Field Service Procedure

Part Number: SP00214

Rev: D

**Narkomed 6000
Version 2.06 Upgrade**

FIGURE 1. CPU1 Location

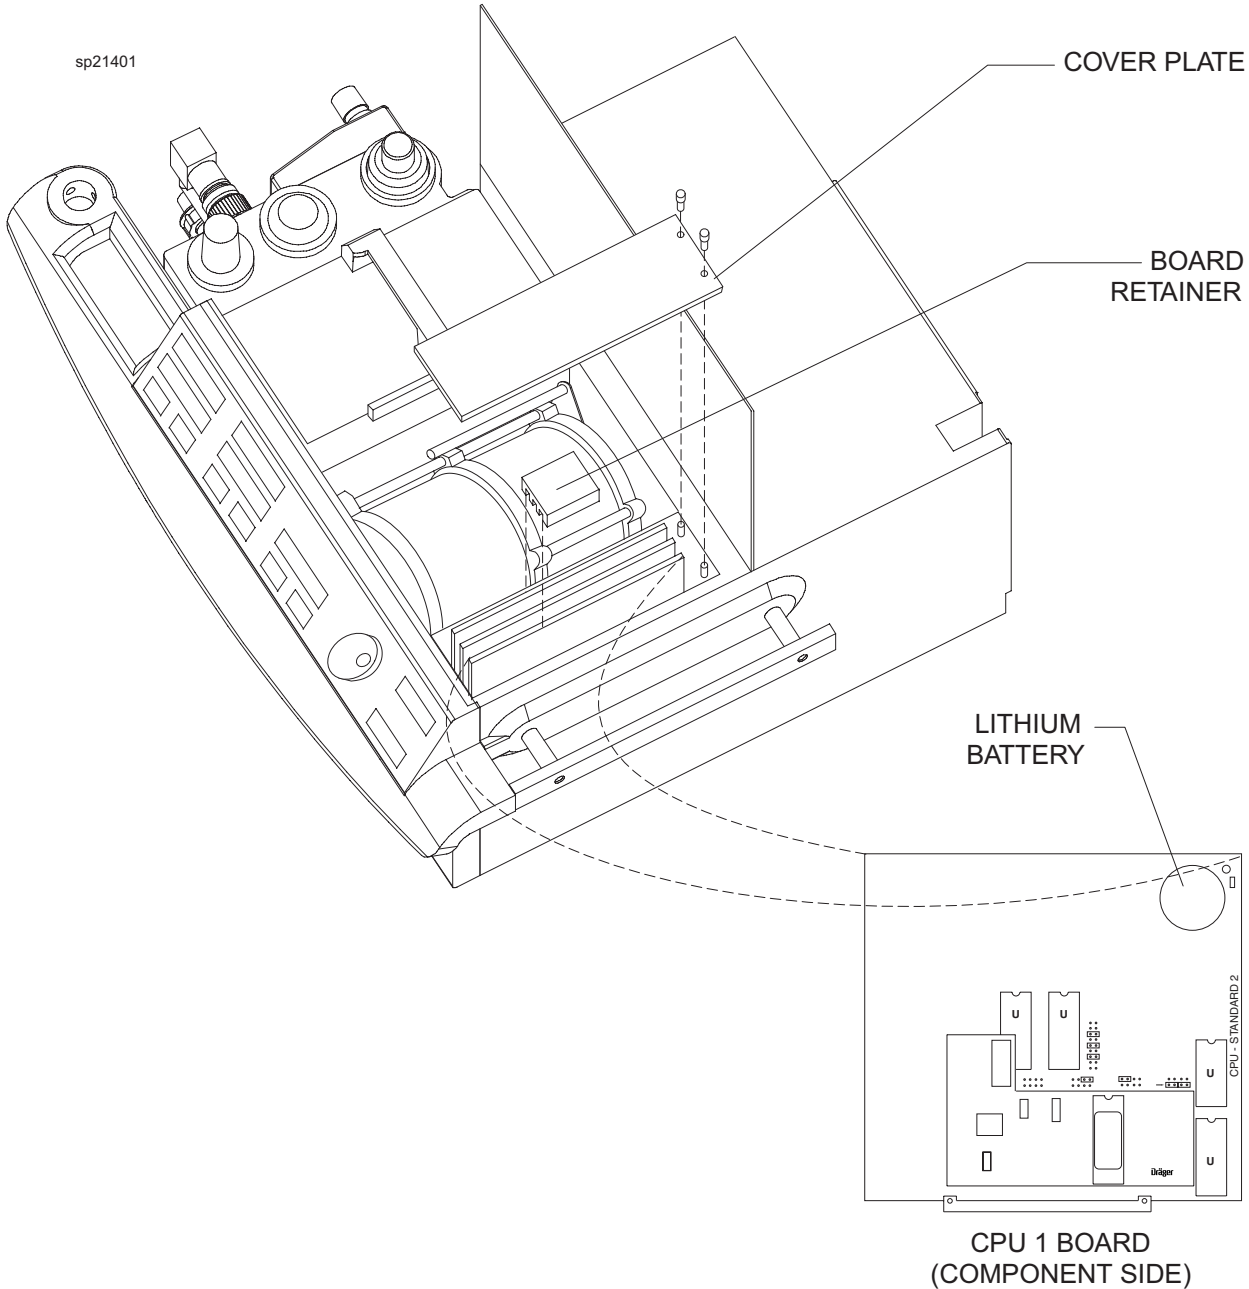
NOTE: This procedure includes the replacement of the original CPU1 (P/N 8305141) with a modified CPU1 circuit board P/N SE8604038 that increases the PCB's lithium battery required replacement interval from one year to six years. Software version 7.40 is installed on this modified CPU1. The CPU2 firmware version 7.40 P/N 4116983-002 included in the kit must be installed on CPU2.

- 2.6 Raise the Divan table top cover to its open position.
- 2.7 Remove the cover plate at the right side of the Divan assembly.
- 2.8 Remove the board retainer.
- 2.9 Identify the location of CPU1 at the Divan's extreme right position. See Figure 1.

- 2.10 Carefully unplug the original CPU1 from the motherboard by raising it straight up and out of its socket.
- 2.11 Insert the replacement CPU1 P/N SE8604038 in the appropriate location. Be certain the PCB is properly aligned and fully seated into the socket. Update the new part number and serial number in the Narkomed 6000's Advanced Service Menu Service Parts notebook at the completion of this machine modification.

FIGURE 4. Divan Leak Test Plug

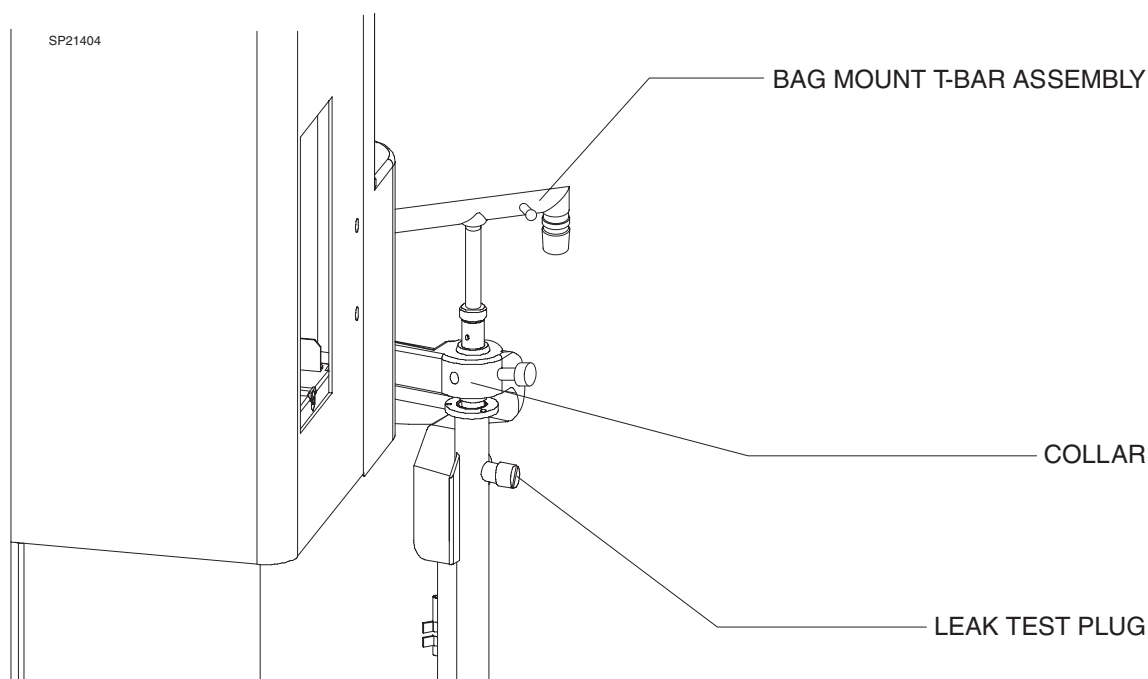
- 4.1 Remove the existing leak test plug. Obtain a Returned Materials Authorization (RMA) for the original plug, P/N 4114550, and ship it within 24 hours (overnite delivery) to DMI Telford via Federal Express. Line #2 of the Air Bill shall indicate Code "B-1." Insert and secure a $\frac{1}{4}$ -28 x $\frac{1}{2}$ in. button head screw P/N HW09079 in this location using red Loctite #271. See Figure 4.

- 4.2 Remove and discard the original bag mount T-bar assembly by unthreading its mounting collar, and install the new style bag mount T-bar with test plug.

FIGURE 5. Suction Warning Label

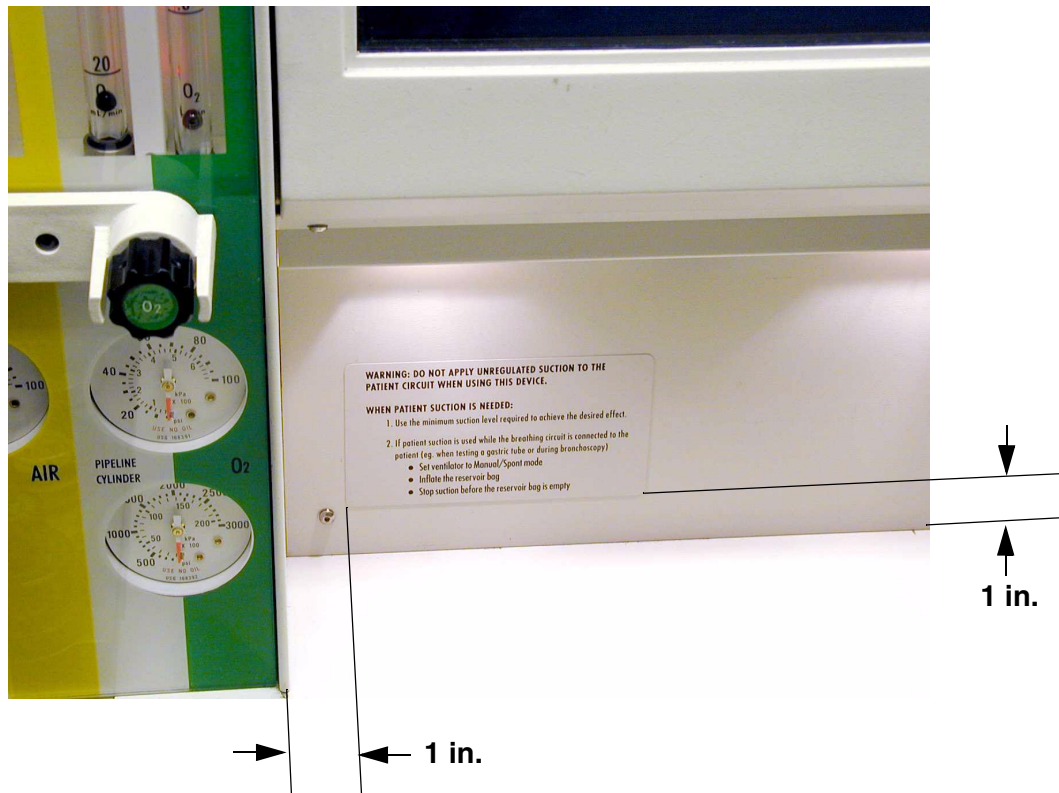
- 5.1 Affix suction warning label P/N 4117092 to the table lamp assembly. Place the label one inch up from the table top and one inch from the left edge of the panel as shown in Figure 5.

FIGURE 7. System I/O Components

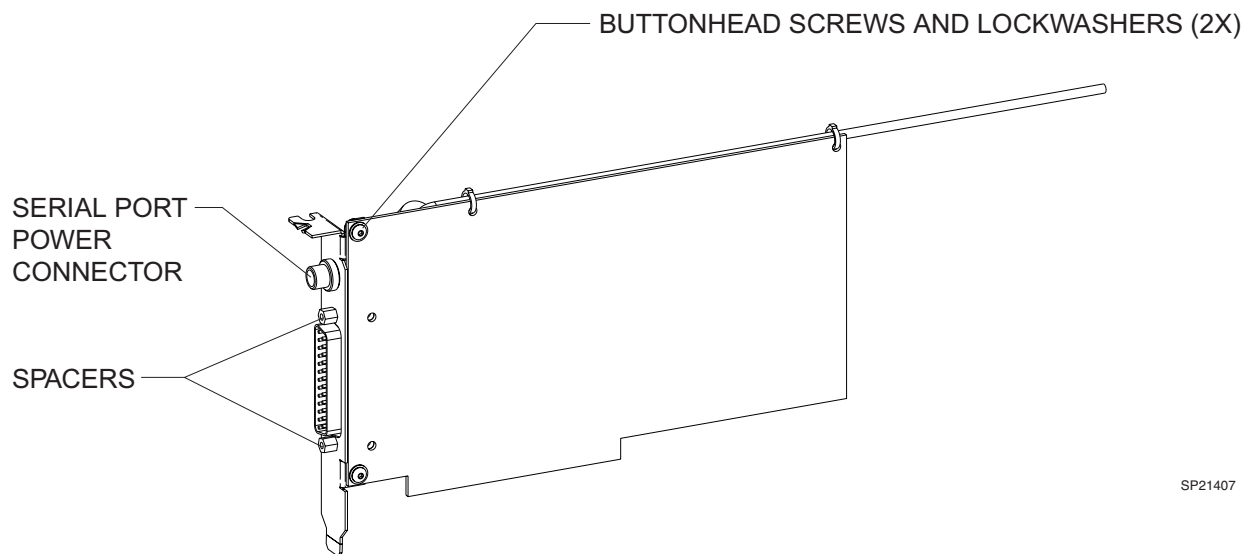
- 6.10 Note the locations and orientation of the components attached to the PCB mounting bracket, then remove the Serial Port Power connector and thumbscrew spacers from the System I/O bracket. If applicable, also remove and discard the button head screws and washers securing the System I/O PCB to its bracket. See Figure 7.

6.11 Secure the System I/O PCB to the new mounting bracket using two new button head screws and lock washers. Reattach the Serial Port power connector to this bracket.

FIGURE 8. PCB Bracket Mounting Clamp

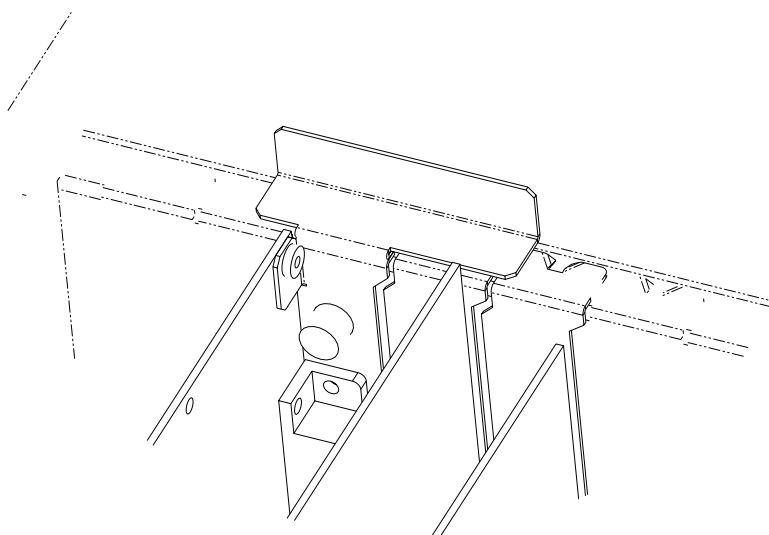
6.14 Install the PCB bracket clamp as shown in Figure 8 using two of the three mounting screws previously removed.

CAUTION: Tighten the lower screw first to reduce the possibility of stripping the threads.

6.15 Grasp the System I/O PCB near the top button head mounting screw and verify the assembly can not be rocked back and forth toward the chassis.

FIGURE 12. System I/O Rework Label

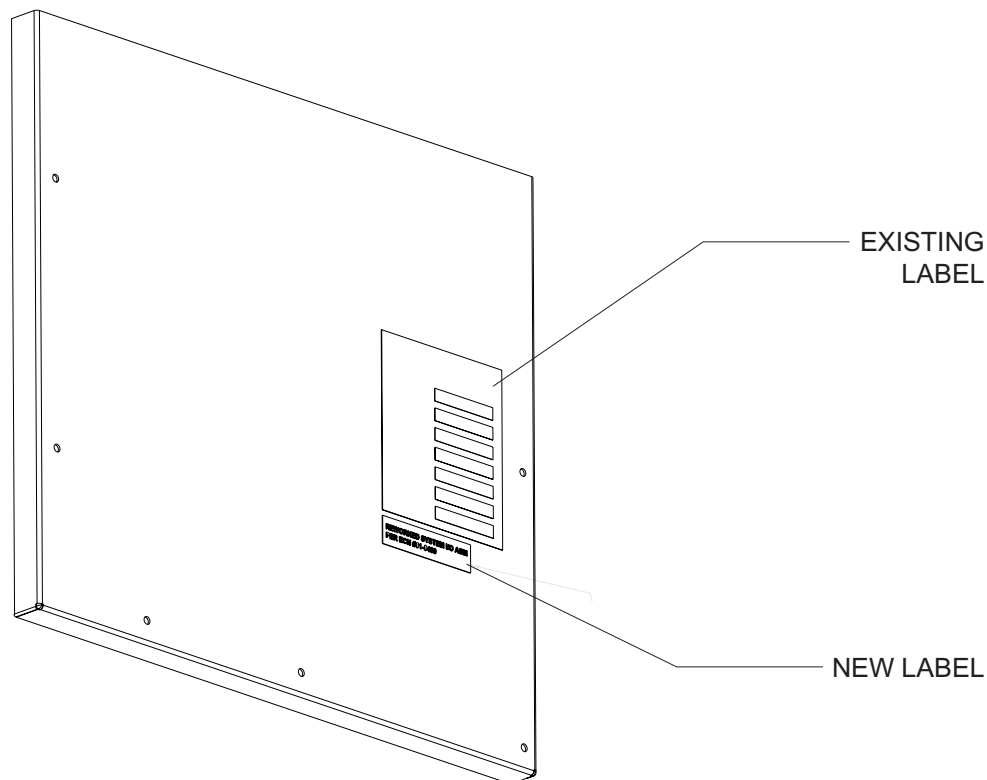
- 6.19 If there is a significant amount of dust and lint buildup in the WPU assembly, use a current limiting ESD vacuum cleaner (Ohmega Supreme or equivalent) to eliminate the debris.
- 6.20 Reinstall the WPU cover plate.
- 6.21 Affix a System I/O Rework Completed label to the WPU cover plate below the existing label as shown in Figure 12.
- 6.22 Reconnect the System I/O cable and secure its thumb screws.
- 6.23 Reconnect and secure the cables previously removed from the power supply.

FIGURE 13. Typical Keylok Installation

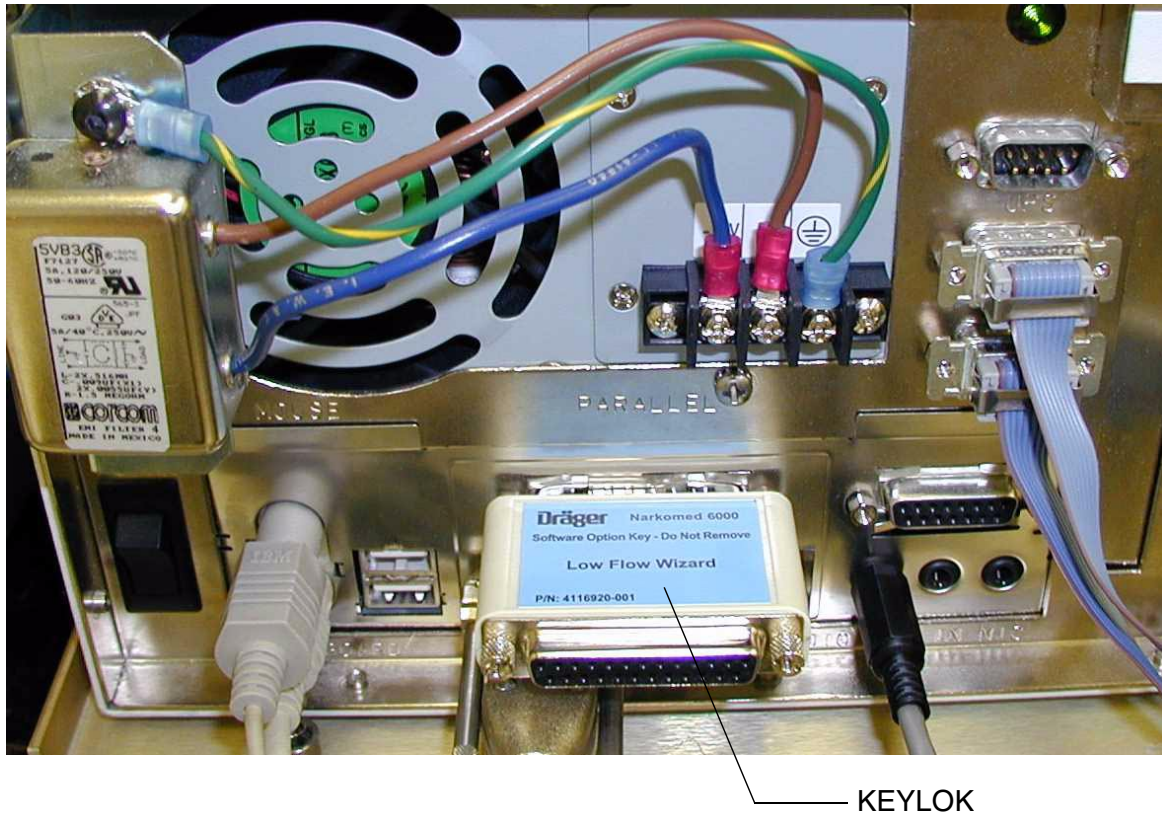
NOTE: With system software version 2.06, the reactivation of Low Flow Wizard and or Air Only Mode software options requires a correctly configured Keylok secured to the WPU printer port, and also requires the software option to be enabled in the Advanced Service menu.

- 6.27 If applicable, obtain the correctly configured Keylok and secure it to the WPU printer port using a small slotted screwdriver. See Figure 13.

FIGURE 14. Power Cord Routing

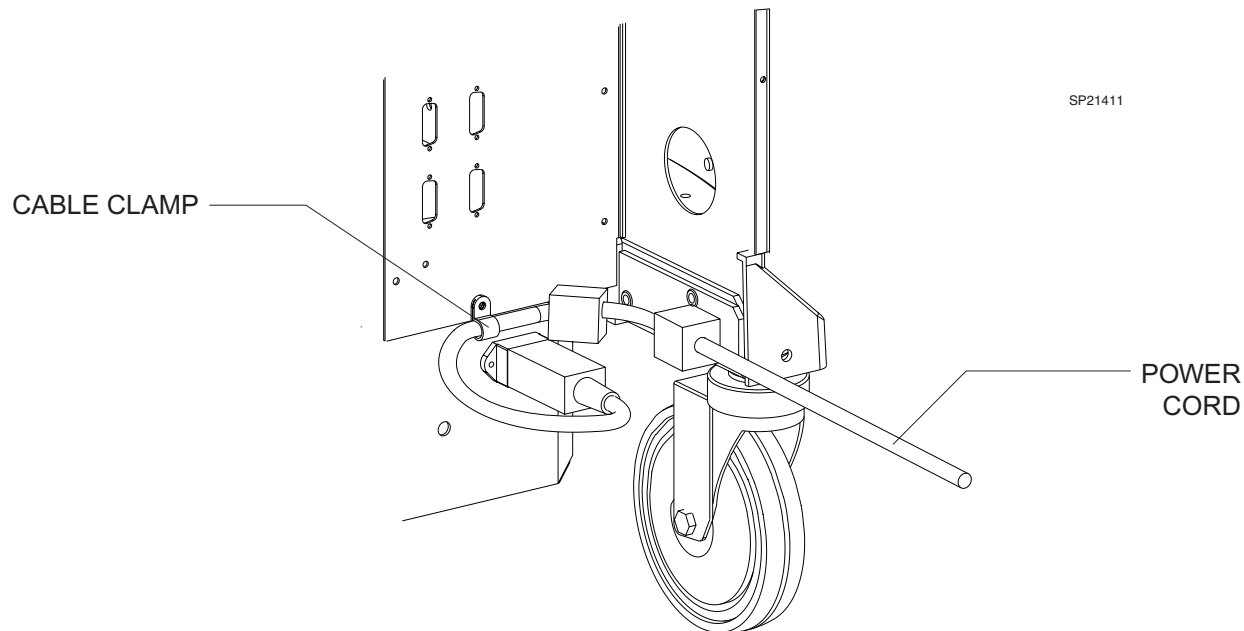
6.30 Route the power cord's strain relief with a loop in a clockwise direction. The retaining clip shall be located $16.6 \pm \frac{1}{4}$ in. (5.25 in. diameter loop approx.) from the cord end, and secured to the Vitalbus Hub door using the mounting hole directly above the power cord socket as shown in Figure 14.

FIGURE 16. GAP Personality PCB

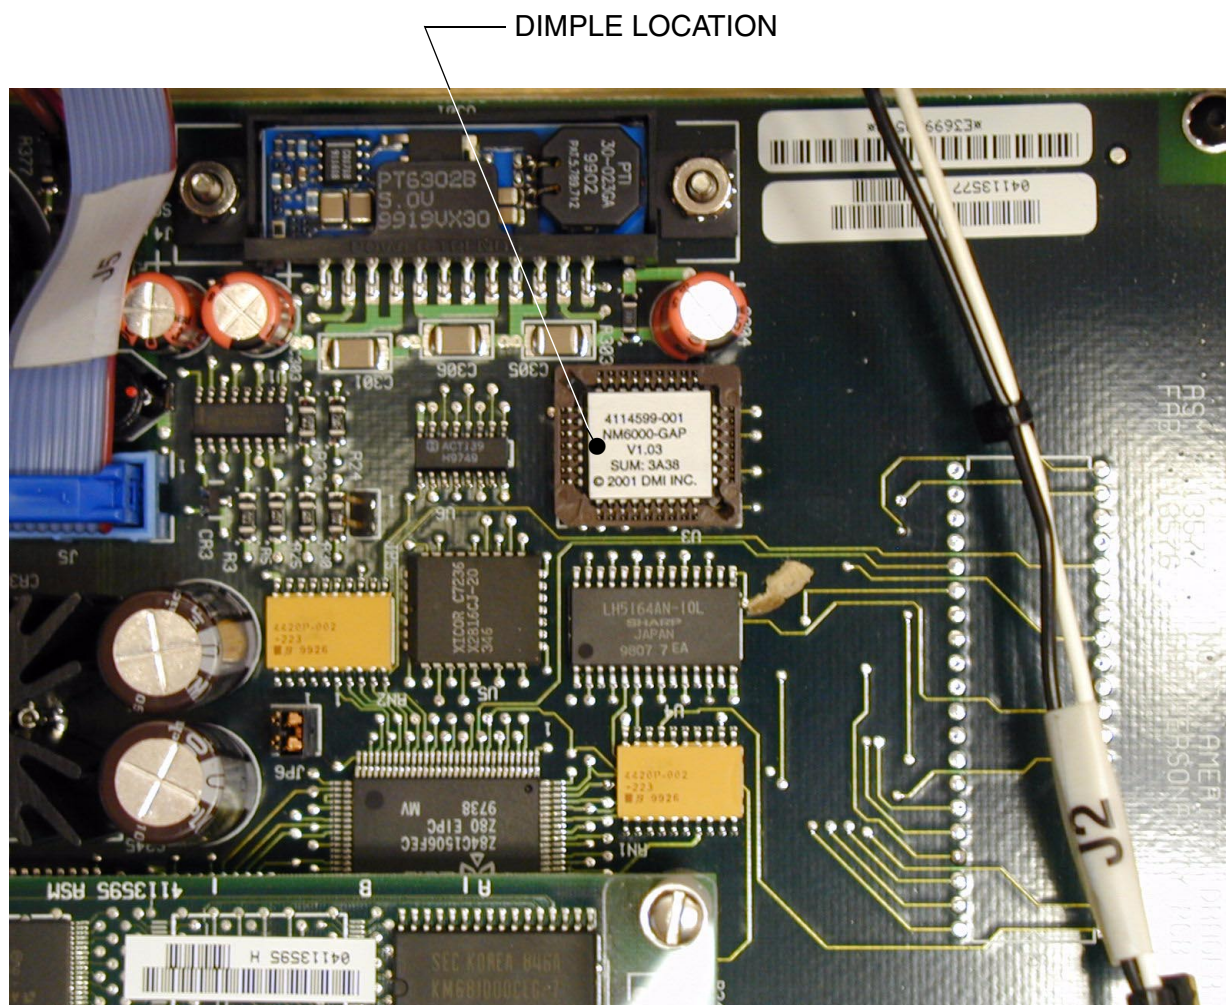
- 7.8 Remove the upper left (facing the back of the machine) back panel from the machine. If there is a significant amount of dust and lint buildup in the monitor compartment, flowmeter housing, Vitalbus, GAP, cockpit vent, or power supply, use a current limiting ESD vacuum cleaner (Ohmega Supreme or equivalent) to eliminate the debris.
- 7.9 Verify all data and electrical cables are completely seated in their corresponding sockets. If the connection has thumbscrews, verify both are secure.
- 7.10 Reinstall the upper left back panel.
- 7.11 Locate and carefully remove the GAP firmware on the GAP personality PCB at Location U3.
- 7.12 On the new GAI firmware P/N 4114599-001: peel back the label's edge to verify the location of its dimple. Orient the firmware as shown in Figure 16 and insert it firmly into the socket.

FIGURE 17. Gas Analyzer Tube Routing

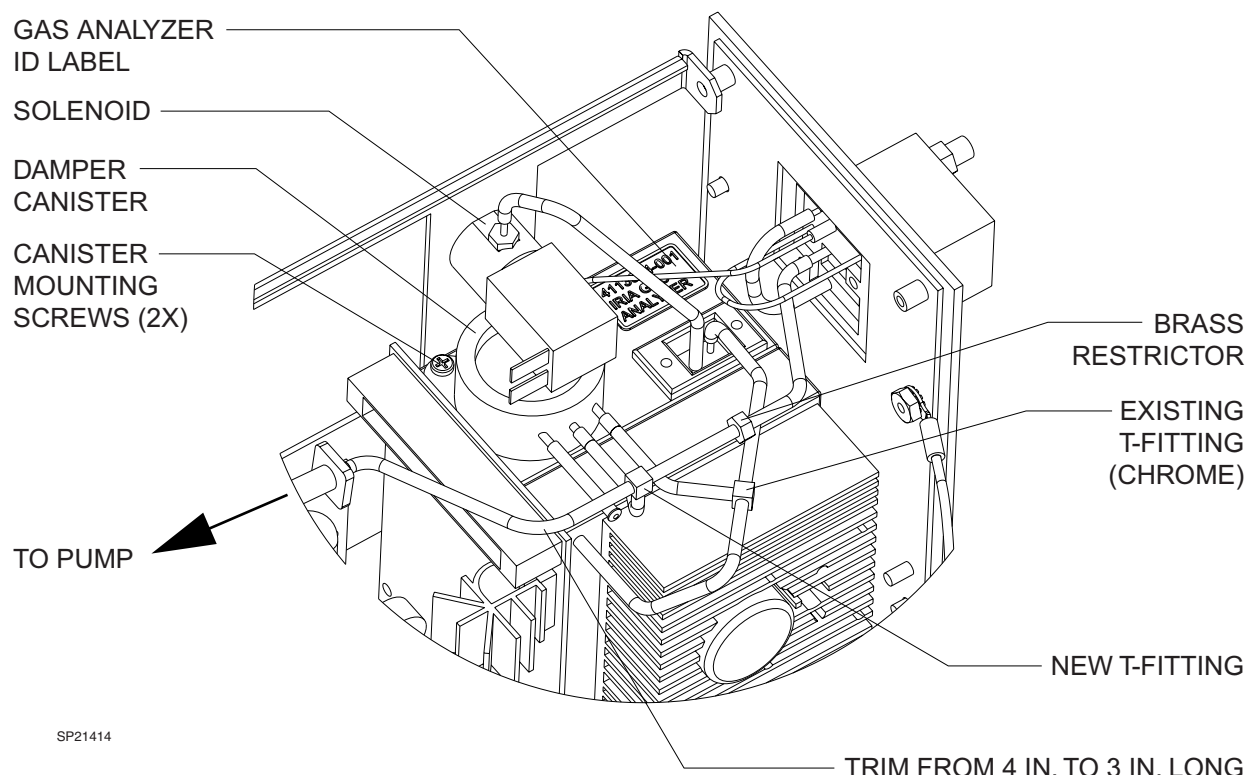
- 7.13 Attach a new IRIA gas analyzer ID label P/N 4116621 to the top right front corner of the IRIA as shown in Figure 17.

- 7.14 Disconnect the small diameter tubing from the T-fitting leading to the pump assembly and trim this tube from 4 in. long to 3 in. long.
- 7.15 Disconnect the larger semi-transparent tube from the chrome T-fitting.
- 7.16 Disconnect the remaining smaller diameter tubes from the white T-fitting and discard this T assembly.
- 7.17 Connect the open port on the chrome T-fitting to the tube on the right side of the damper.
- 7.18 Install a new T-fitting P/N 4102337 onto the tube leading to the pump and the tube leading to the brass restrictor. Connect the remaining T port to the center port on the damper.
- 7.19 Secure the damper canister assembly P/N 4117237 in the existing holes at the top of the IRIA, and secure the assembly using two self-tapping screws P/N HW13004.
- 7.20 Check to ensure the lower tube connection from the solenoid is routed behind the damper canister.
